Submission on the stage 1 contingent project application for the HumeLink project – Kyeamba Valley Concerned Landowners Group and Westwood Action Group, May 2022

Kyeamba Valley Concerned Landowners Group and Westwood Action Group submit the following objection to the Australian Energy Regulator (AER) on [TransGrid's Contingent Project Application for HumeLink Stage 1 \(Early Works\), 5 April 2022](#).

Figure 6 shows the overall estimated net benefit for each option under the central scenario.

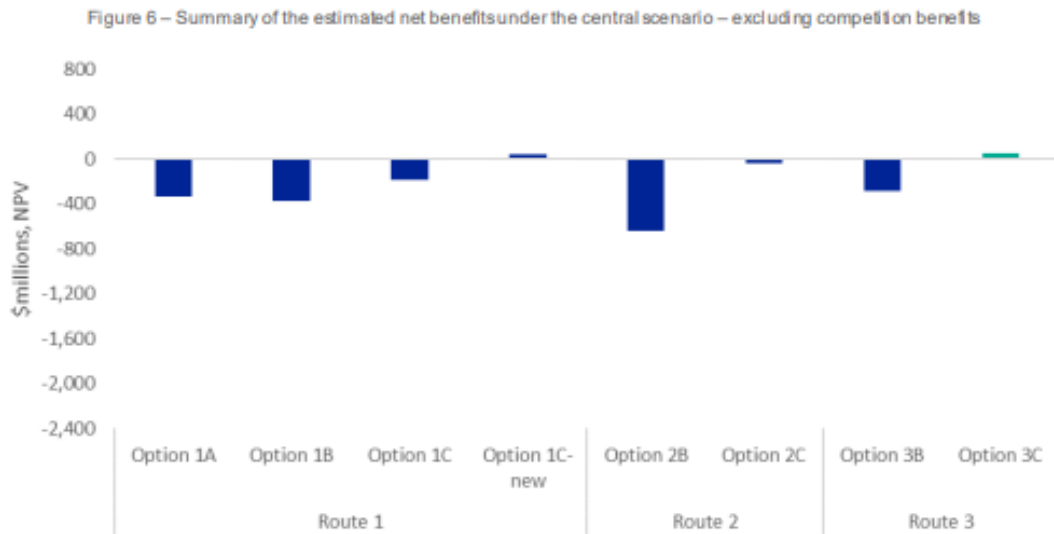
Irrespective of the inconsistencies, it is our strong view that Option 1C-new assessed in the Addendum to the PACR, is the optimal solution. The net benefit is \$40m for Option 1C-new and \$49m for Option 3C for the Central scenario. This is a \$9m difference, insignificant for a \$3.317 billion project (see Figure 6 below). By any objective measure, Option 1C-new that is 94 km shorter (a quarter shorter) than Option 3C, with substantially less environmental impacts, is undoubtedly the preferred option.
